IEEE P802.15 Wireless Personal Area Networks

Project	IEEE P802.15 Working Group for Wireless Personal Area Networks (WPANs)	
Title	TG3 SB1 comment resolution	
Date Submitted	[13 February, 2003]	
Source	[James P. K. Gilb] [Apparent Technologies] [15373 Innovation Drive, #210, San Diego, CA 92129]	Voice: [858-485-6401] Fax: [858-485-6406] E-mail: [gilb@ieee.org]
Re:	[]	
Abstract	[This document is a record of comment resolutions for SB1.]	
Purpose	[To provide a record of the comment resolution for SB1.]	
Notice	This document has been prepared to assist the IEEE P802.15. It is offered as a basis for discussion and is not binding on the contributing individual(s) or organization(s). The material in this document is subject to change in form and content after further study. The contributor(s) reserve(s) the right to add, amend or withdraw material contained herein.	
Release	The contributor acknowledges and accepts that this contribution becomes the property of IEEE and may be made publicly available by P802.15.

Figure 6—MSC for acquiring DEV IEs using the Probe Request command.

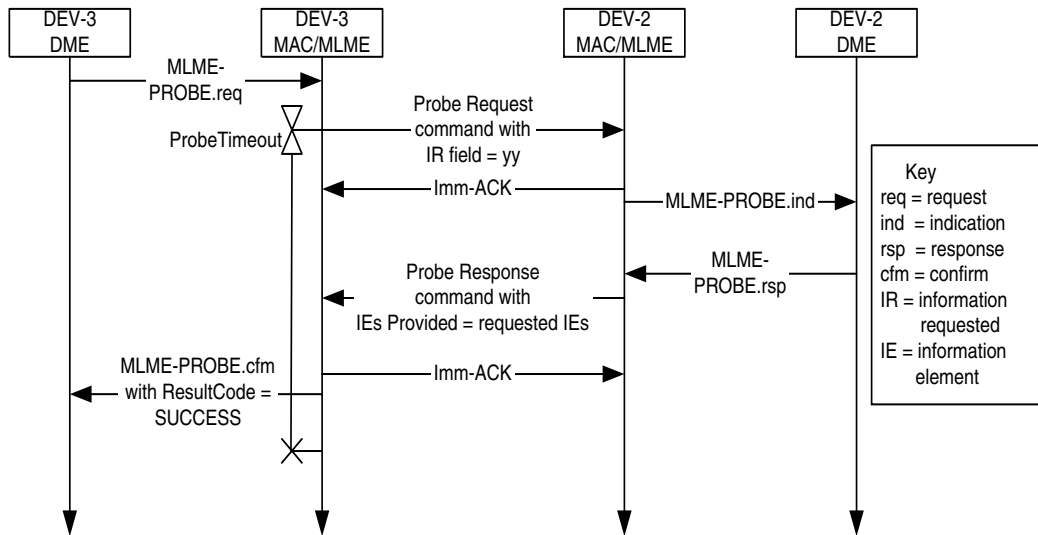
Figure 6 illustrates the sequence of messages involved in acquiring DEV IEs from a target DEV using the Probe Request command.

The Probe Request command provides the ability to request information elements from a target DEV. If the target DEV receives the Probe Request command, it shall respond to the originator with a Probe Response command that shall have the IEs requested by the originator.

Figure 7—MSC showing sending of information using Probe command

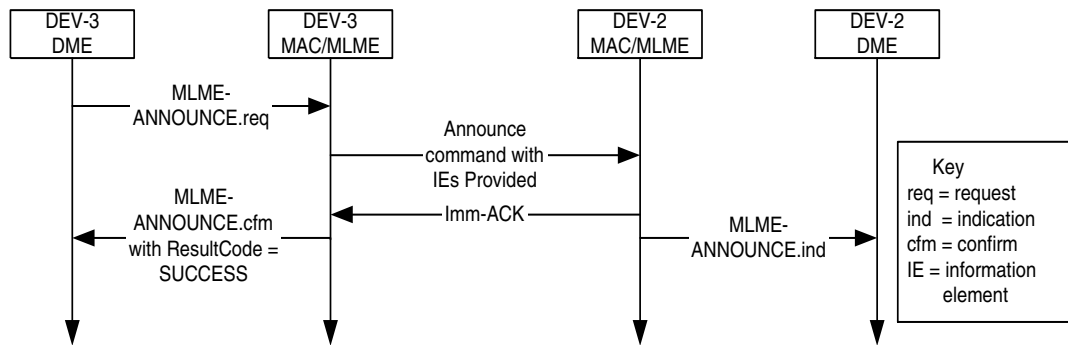
Figure 7 illustrates the sequence of messages involved in using the Announce command for sending information.

Figure 8—CTRq time unit covering multiple frames with CTRq TU MIFS = 1

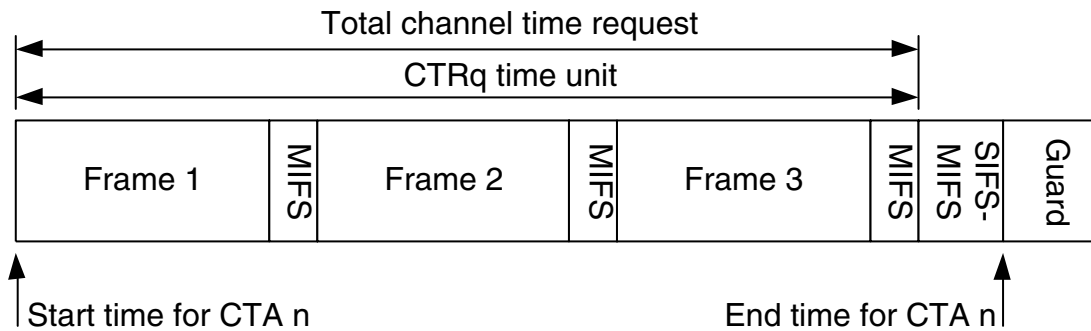
CID 682 - Needed to add one more figure, see also 03/059r0 for complete section. The new figure and text are:

Figure 8 shows a multi-frame CTRq with the CTRq TU MIFS field set to 1.

Figure 9—PNC sending the piconet services command to a newly associated DEV in response to a request in the association proces.

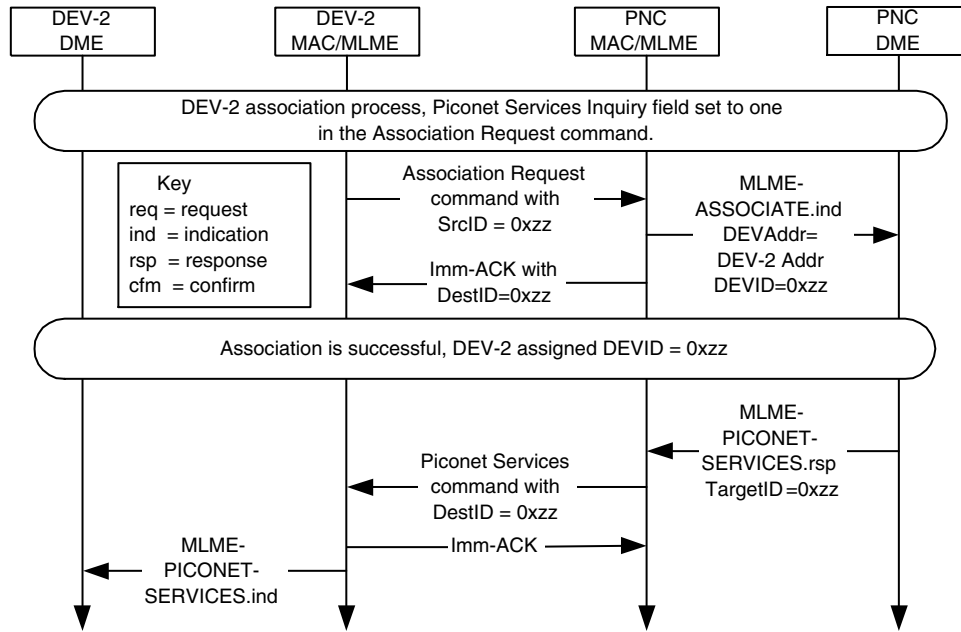
CID 299 (Sarallo, assigned to Bain) - The sentence "The association process does not wait for the piconet services command to complete." can result in problems. For example, if the association process completes before the PNC transmits the piconet services command, the newly associated dev would not receive the command because the command is addressed to the UnssocID and not the associated DEVs newly acquired DEVID. Change: "If the DEV sets the piconet services inquiry bit, the PNC shall send the piconet services command, 7.5.4.6, with DestID set to UnassocID. The association process does not wait for the piconet services command to complete." To: "If the DEV sets the piconet services inquiry bit, the PNC shall send the piconet services command, 7.5.4.6, with DestID set to UnassocID before it allocates a DEVID to the associating DEV via the association response command." **Suggest accept in principle:** “Change: ‘If the DEV sets the piconet services inquiry bit, the PNC shall send the piconet services command, 7.5.4.6, with DestID set to UnassocID. The association process does not wait for the piconet services command to complete.’ To: ‘If the DEV sets the piconet services inquiry bit, the PNC shall send the piconet services command, 7.5.4.6, with DestID set to UnassocID before it allocates a DEVID to the associating DEV via the association response command.’ Also, add a new paragraph to 8.3.1 at line 51 on page 172. ‘If the PNC is going to send the piconet services command, {xref 8.3.2}, it shall do so prior to sending the association response command.’ In figure 103, insert a message after MLME-ASSOCIATE.rsp and before association response command. This message is in the direction of PNC MLME to DEV-2 MLME . ‘Piconet services command with DestID=UnassocID (note: this command is only sent if PNC is to provide this command)’. There is no ack.”

Accept in principle “Change to ‘If the DEV sets the piconet services inquiry bit, the PNC shall send the piconet services command, 7.5.4.6, with DestID set to newly assigned DEVID after that PNC

has received the second Association Request command from the DEV, {xref}. This process is illustrated in {figure xx}.’ and add new MSC as shown in 03/032r10.”

Figure 15—Channel time request for frames with immediate ACKs

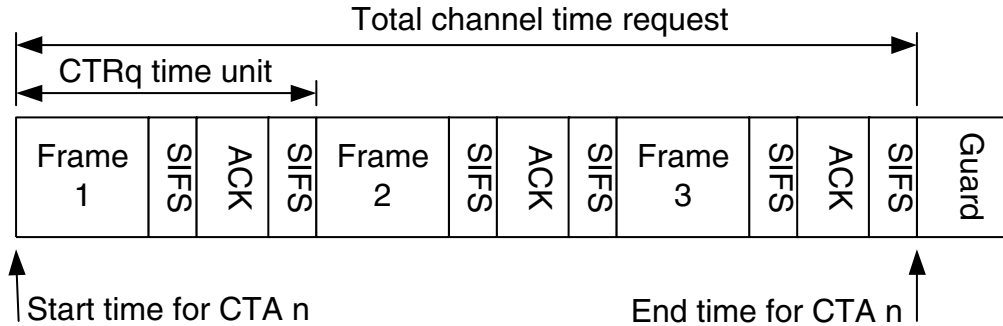
CID 682: - **Suggest accept in principle:** The inclusion of MIFS changed the CTR calculations, but the changes were not reflected in 8.4.4.6. '1)Change b3 in Figure 79 from "stream termination" to "MIFS CTRq TU". 2)Replace page 152, line 12 with:

requests. Figure 15 (was #108) shows an example of channel time being requested for a CTA where Imm-ACKs are used.
